Village of Downers Grove

Report for the Village Council Meeting

Subject	1205 - 1219 Ogden Avenue – Vacation of Public Alley, Final Plat of Subdivision, Planned Unit Development, Zoning Map Amendment and a Special Use
Submitted By	Stan Popovich, AICP, Director of Community Development

OPENING DAY TRAFFIC MITIGATION PLAN

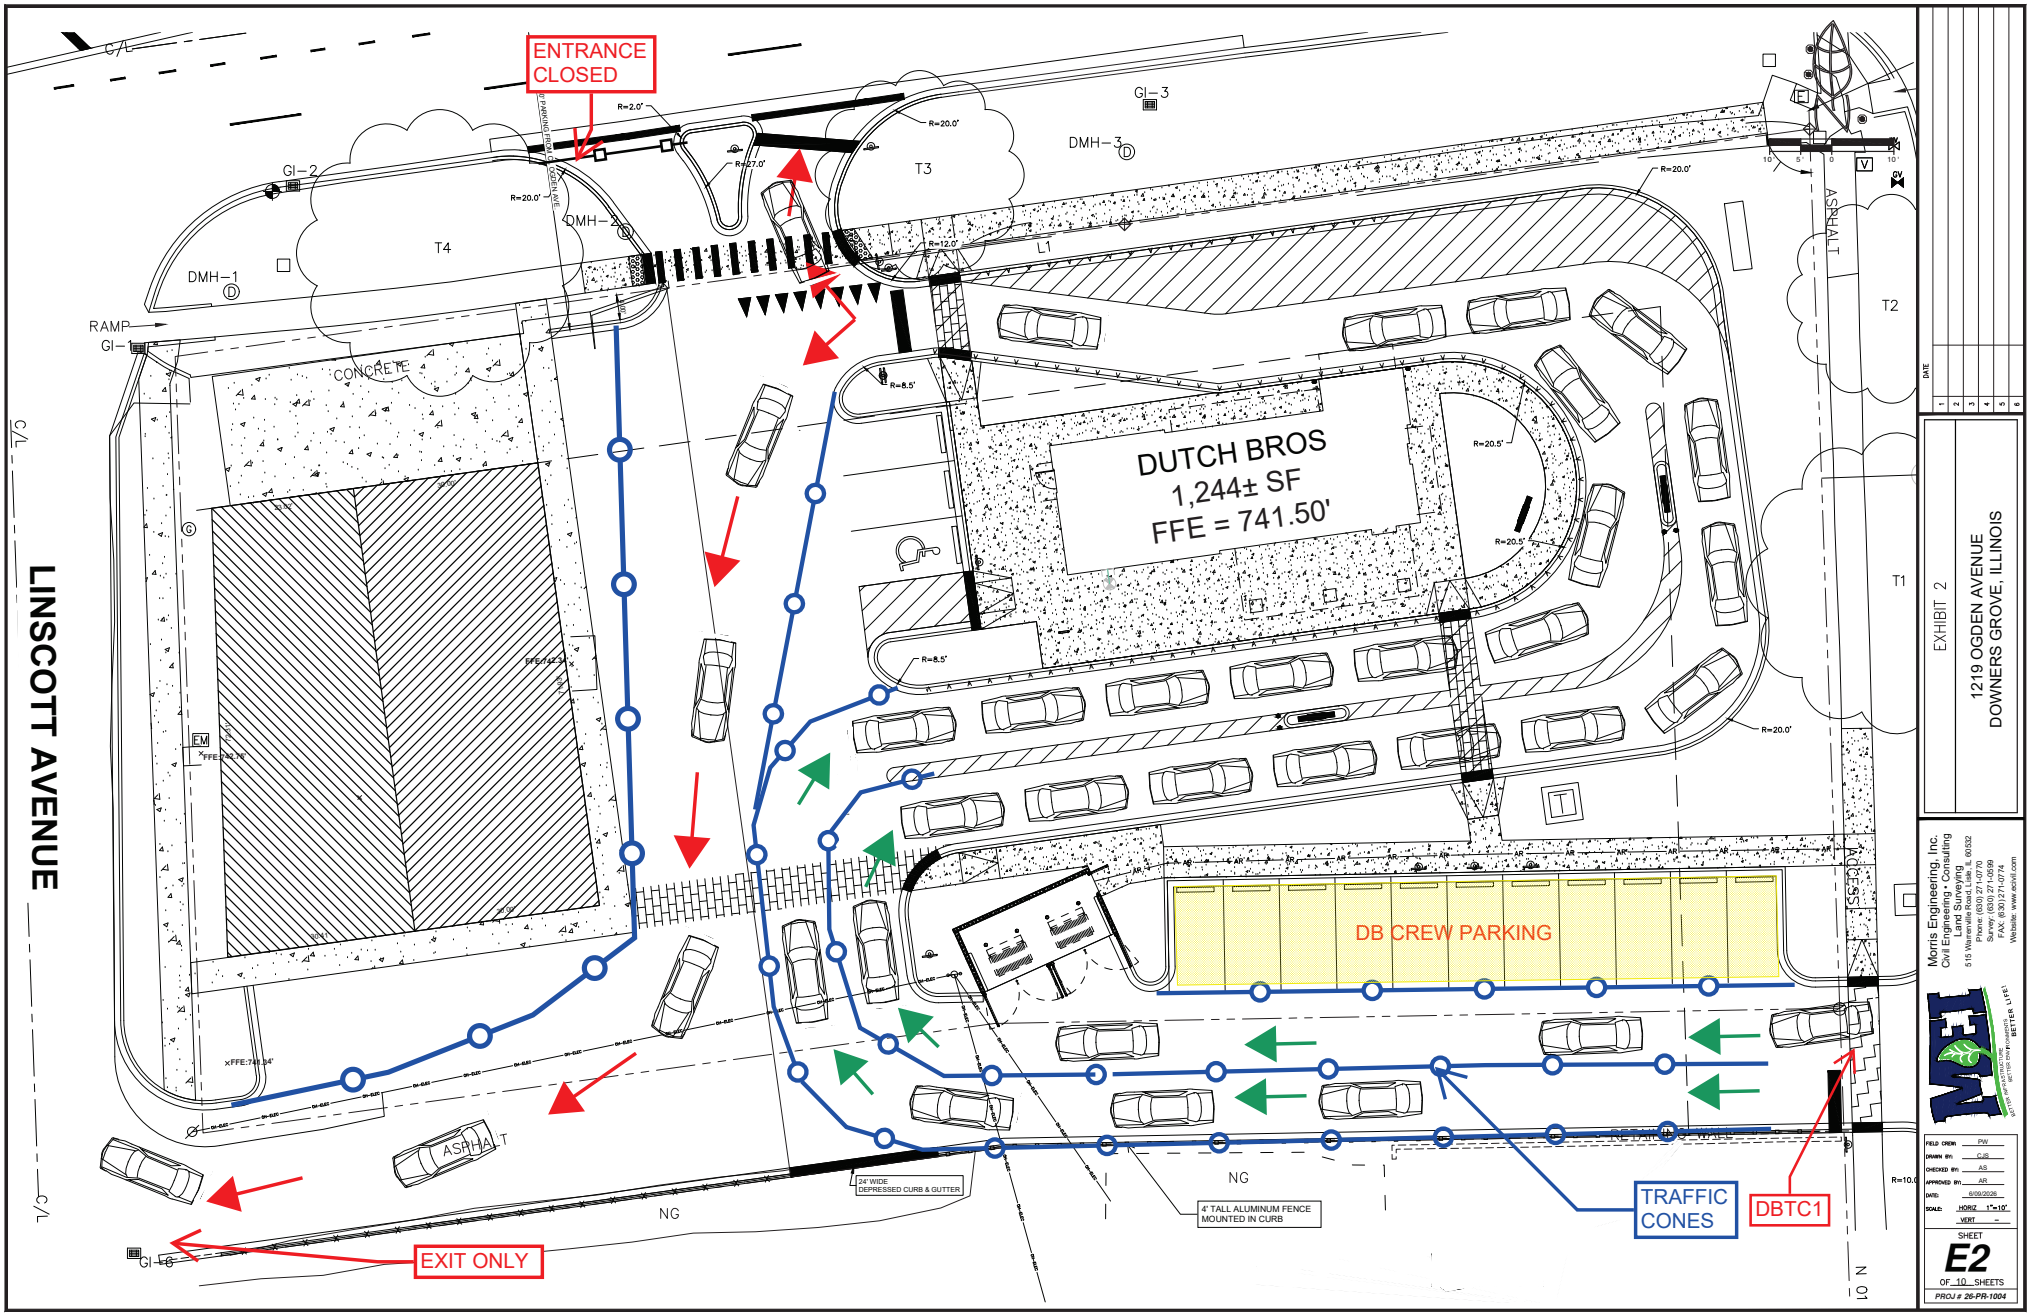
In an effort to alleviate concerns about potential higher traffic during the grand opening period, the petitioner provided a traffic mitigation plan.

#12. The petitioner shall operate the Dutch Bros. drive-through during their grand opening period in a manner acceptable to the Community Development Director. Throughout the grand opening period, Dutch Bros. shall provide on-site personnel to direct traffic and ensure that stacked cars do not impede traffic circulation on adjacent roadways and sidewalks. The length of the grand opening period shall be determined by the Community Development Director, not to exceed six (6) months from the opening date.

#13. The petitioner shall submit and operate pursuant to a grand opening traffic circulation plan in a manner acceptable to the Community Development Director. The circulation plan shall be in place for as long as the grand opening period is in place as noted in Condition 12 above. If directed by the Community Development Director, the petitioner shall use a portion of Lot 1 (phase 2) to provide additional vehicle stacking for customers during the grand opening period.

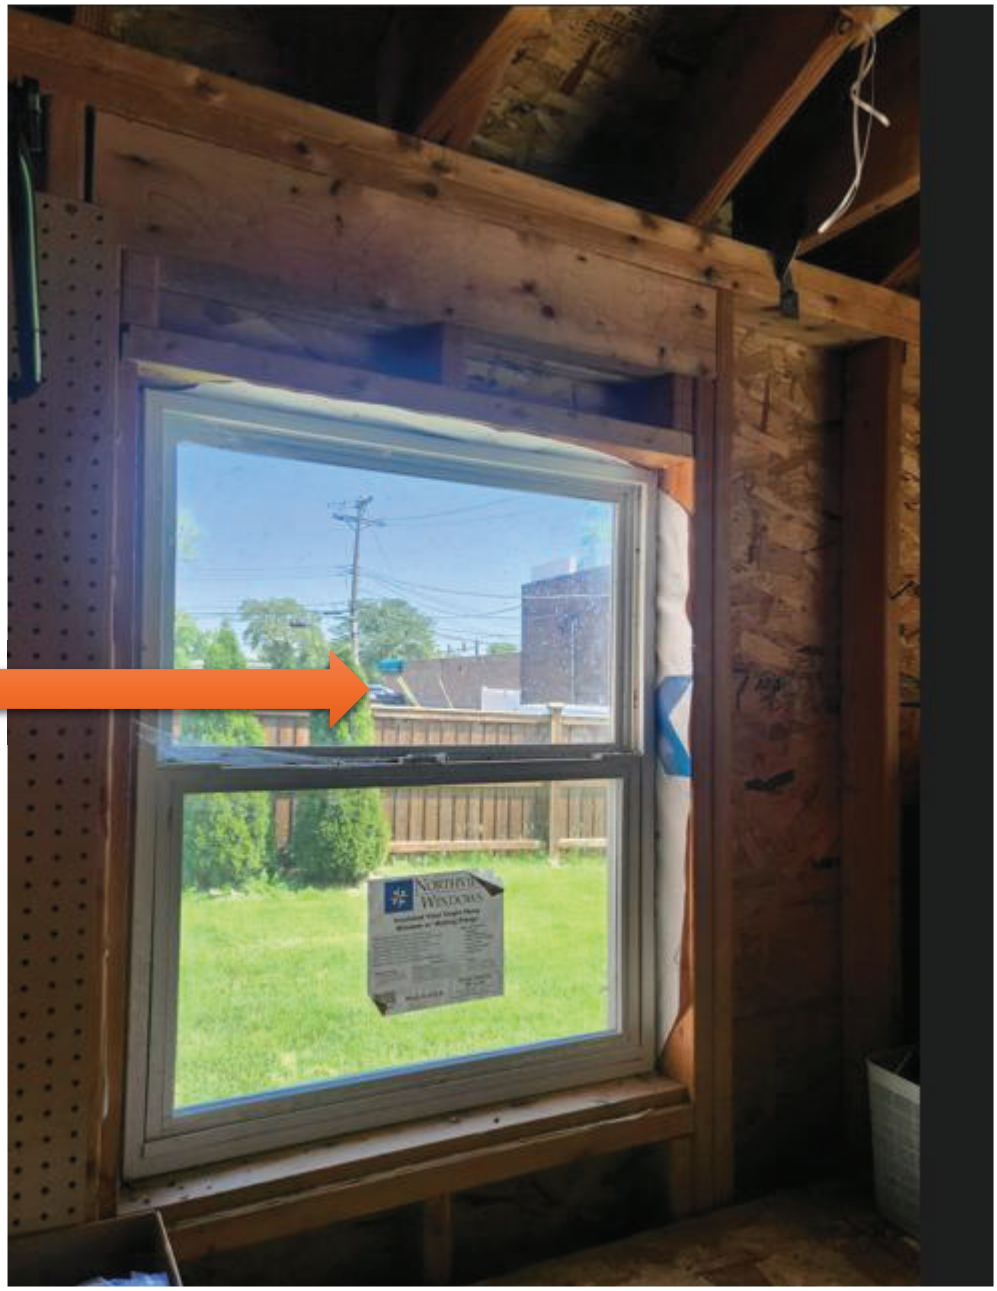
1.) View from Garage, No sound barrier will be present, direct residential exposure of cars, customers, noise and lights.

Where the Dutch brothers building will be located as well as menu, employees, customers, and walk up window.

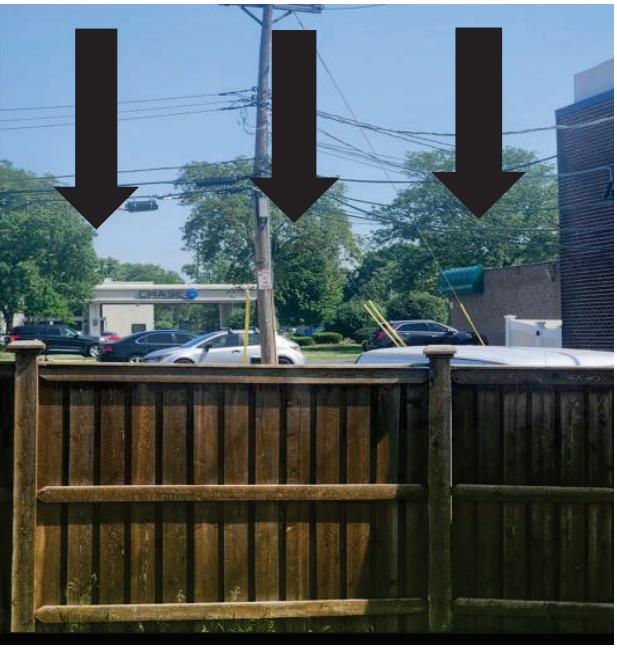
2.) View from behind our garage, where we have an active play area for our children with a swing set, No sound barrier will be present, direct residential exposure of lights, cars, customers, and constant noise (4:30am-11:30pm/12am). Cars will face directly into our yard due to the right turn from Ogden to sit and wait to enter the drive-thru line. (Constant flow of cars facing into our yard and home AM to PM).

Where cars will turn in off of Ogden to wait to turn left into the drive thru lane and cars waiting in drive thru lanes.

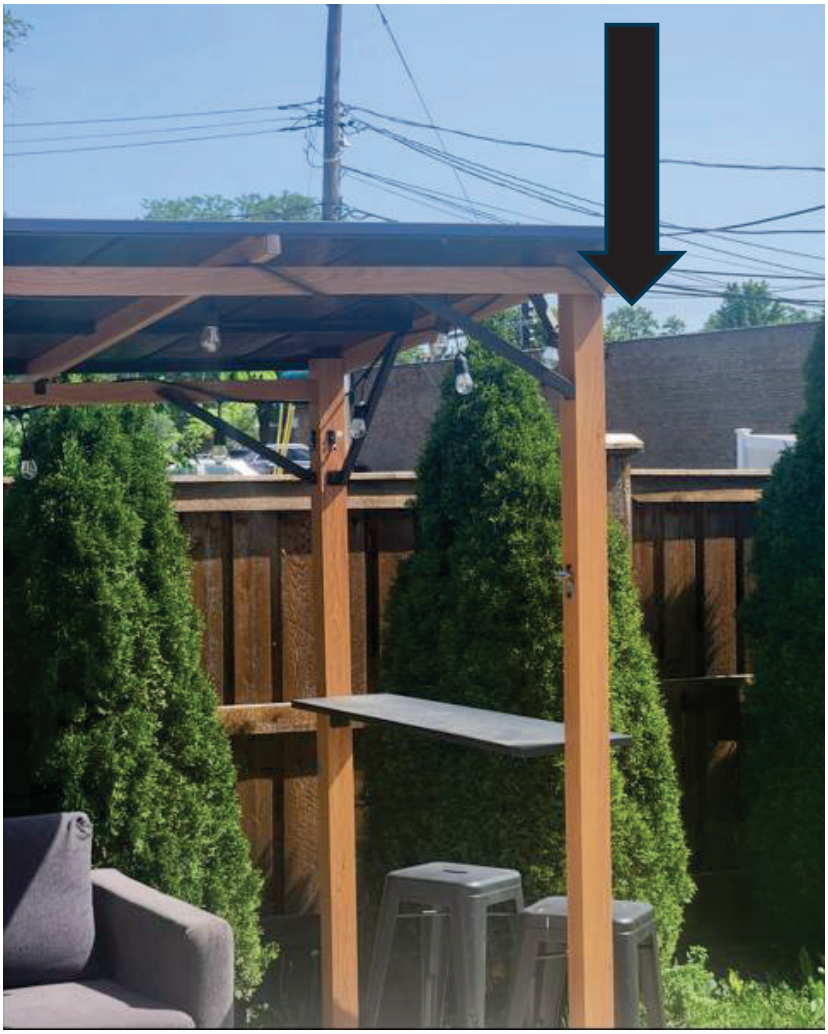
3.) View from one angle of our backyard patio. No sound barrier will be present, direct residential exposure of lights, cars, customers, and constant noise (4:30am-11:30pm/12am).

Where building, walk-up window, as well as drive-thru waiting lines will be in view.

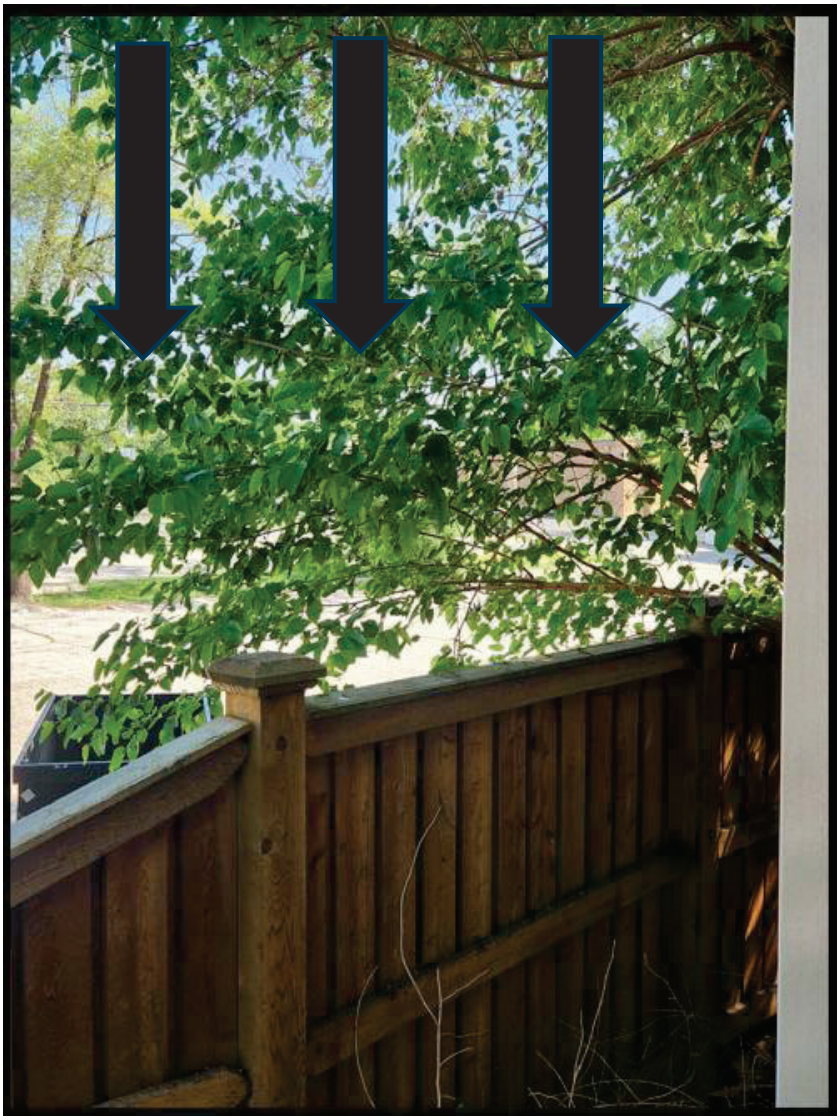
4.) View from children's playroom. No sound barrier will be present, direct residential exposure of lights, cars, customers, and constant noise (4:30am-11:30pm/12am).

Once the leaves fall off the trees, the view will be extreme of all issues.

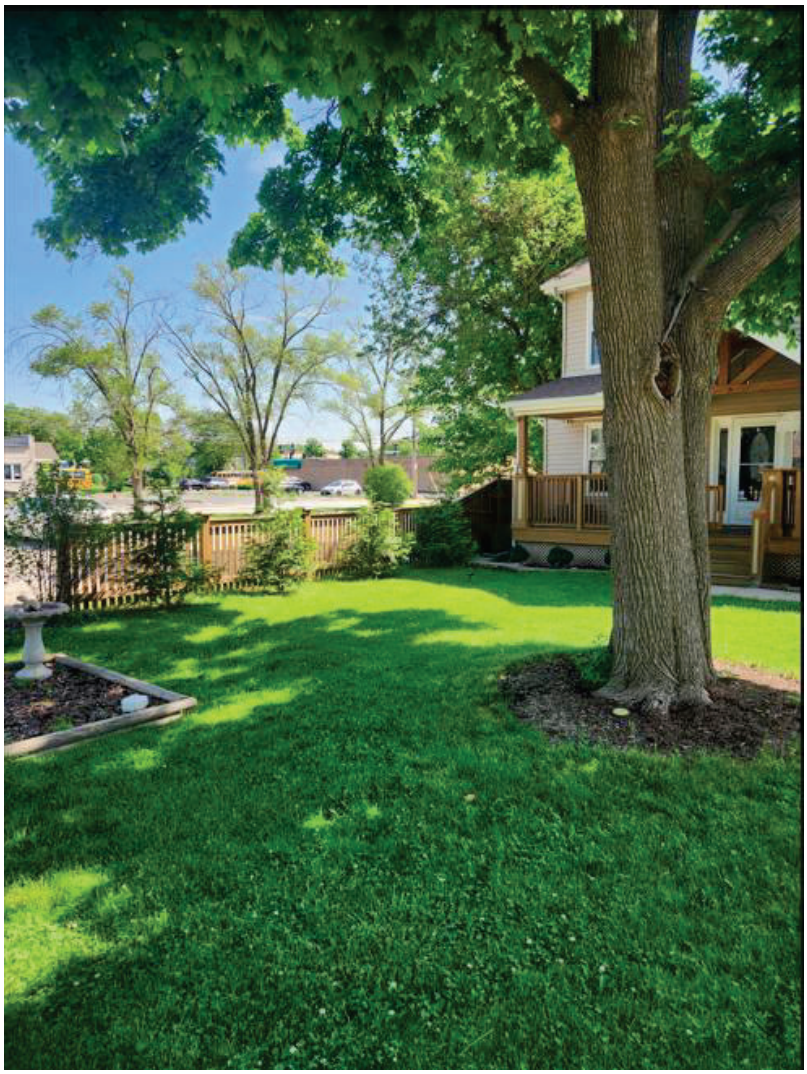
5.) View from master bedroom. No sound barrier will be present, direct residential exposure of lights, cars, customers, and constant noise (4:30am-11:30pm/12am).
